**Washington State
Department of Transportation**

RE: NEW 144 – AUTO FERRIES
DESIGN - BUILD CONTRACT NO. 00-6674

ADDENDUM NO. 19

COMPOSITE ARCHITECTURE

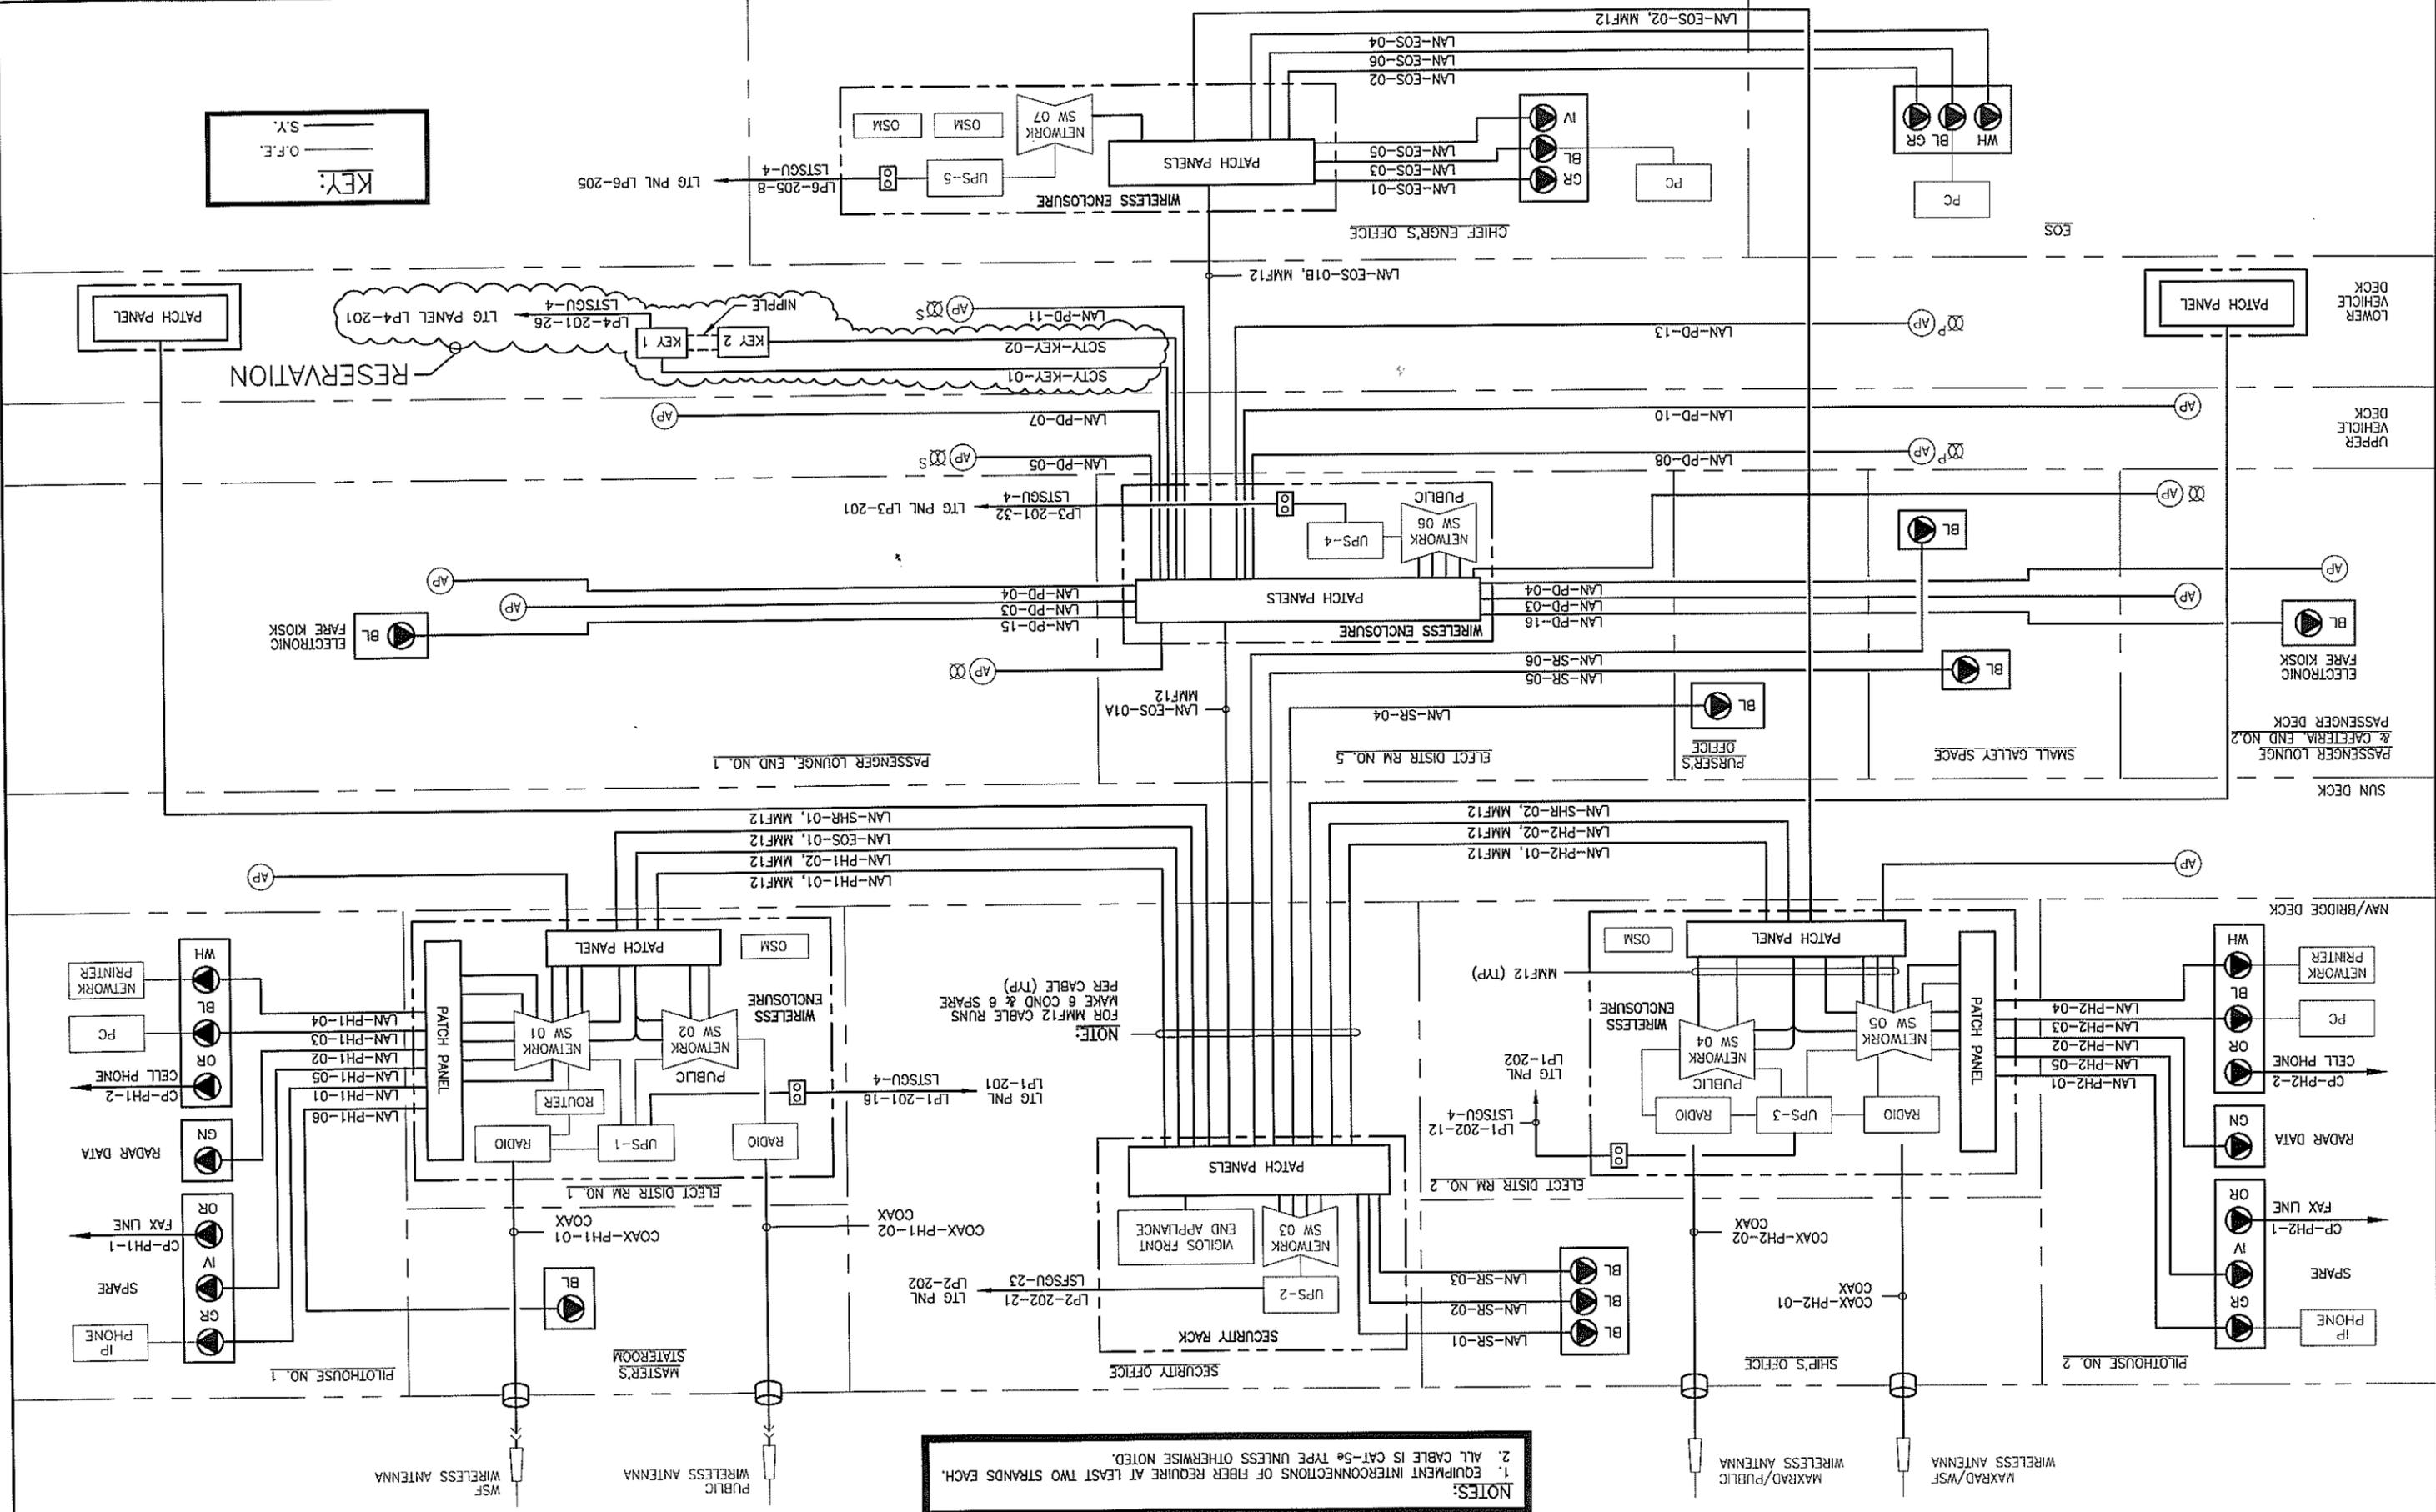
"via wireless antennas throughout the Passenger and Vehicle Deck areas."
33. Revise RFP Volume IV, Section 95, Figure 95-2, by replacing the Figure with the attached Figure 95-2 Rev. A.
34. Revise RFP Volume IV, Section 100, paragraph 100.4.4, "Administrative Plans", page 4 of 61, line 21, replace the words "Sections of the Outline Specification" with the following:
